KOALA KOALITION ECONETWORK PORT STEPHENS INC.

Re: Kings Hill Precinct 6 DA 16-2024-174 Lot 41 DP 1037411

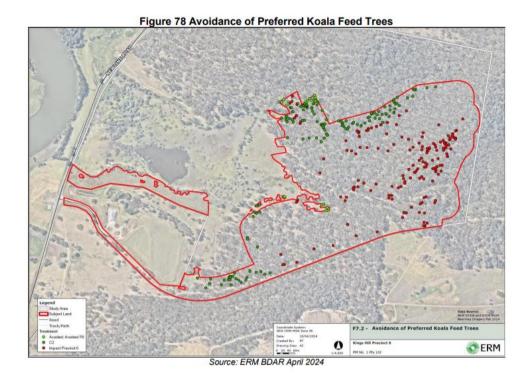
Precinct 6 proposes to clear another 24 hectares that should not be approved (see fig 78, p103).

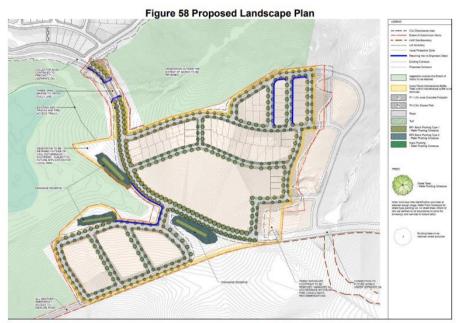
Fig 58 and fig 64 Show koala fencing on both sides of the connecting road from Precinct 7 to Precinct 6 when koalas and other terrestrial wildlife should be able to move through this area. The koala fencing location requires redesign with greater consideration to corridor connectivity and access to revegetation areas LMZ4 intended for koalas losing habitat on this site.
